Access Compliance Report

Public Rights-of-Way

Intersection ID: 48280	Main Street: KELSEY_WOODS_CT	Cross Street: ROBINWOOD_DR	Location: NW
ADA ID: FCC62D2201C2	Ramp Type: PerpDiag	Initial Pass/Fail: Fail	Overall Compliance: No
		Severity Score: 10

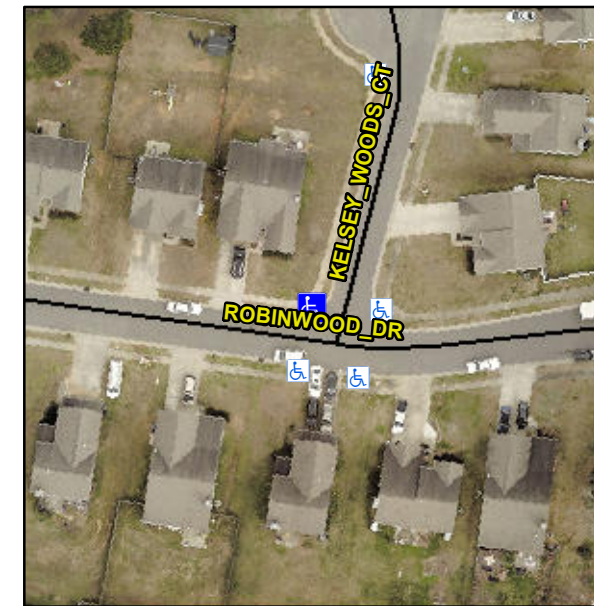
Not Found, R304.5.1, R304.5.3

Compliance	Description	Data	Compliance	Description	Data
N/A	Ramp Length (in)	49.0	Yes	Ramp Slope (%)	6.2
No	Ramp Width (in)	47.0	No	Ramp XSlope (%)	2.4
N/A	Flare Type LT	N/A	N/A	Flare Type RT	N/A
N/A	Flare Slope LT (%)	N/A	N/A	Flare Slope RT (%)	N/A
N/A	Flare Traversable LT?	N/A	N/A	Flare Traversable RT?	N/A
N/A	Landing Length (in)	N/A	N/A	DWS Provided?	N/A
N/A	Landing Width (in)	N/A	N/A	DWS Contrast?	N/A
N/A	Landing Slope (%)	N/A	N/A	DWS Length (in)	N/A
N/A	Landing X Slope (%)	N/A	N/A	DWS Full Width?	N/A
N/A	Landing Curb? (Y/N)	N/A	N/A	DWS Offset (in)	N/A
N/A	Shared Landing?	N/A			
N/A	Gutter Ponding?	N/A	N/A	Gutter Slope (%)	N/A
N/A	Gutter Lip Ht (in)	N/A	N/A	Gutter X Slope (%)	N/A
N/A	Painted X Walk1?	No	N/A	Painted X Walk2?	No
	X Walk 1 Direction	To S		X Walk 2 Direction	To E
N/A	X Walk 1 Width (in)	N/A	N/A	X Walk 2 Width (in)	N/A
	X Walk 1 Slope (%)	3.5		X Walk 2 Slope (%)	1.9
	X Walk 1 X Slope (%)	2.5		X Walk 2 X Slope (%)	3.8

Remove & Replace Curb Ramp With Two New Directional Ramps or Equivalent.
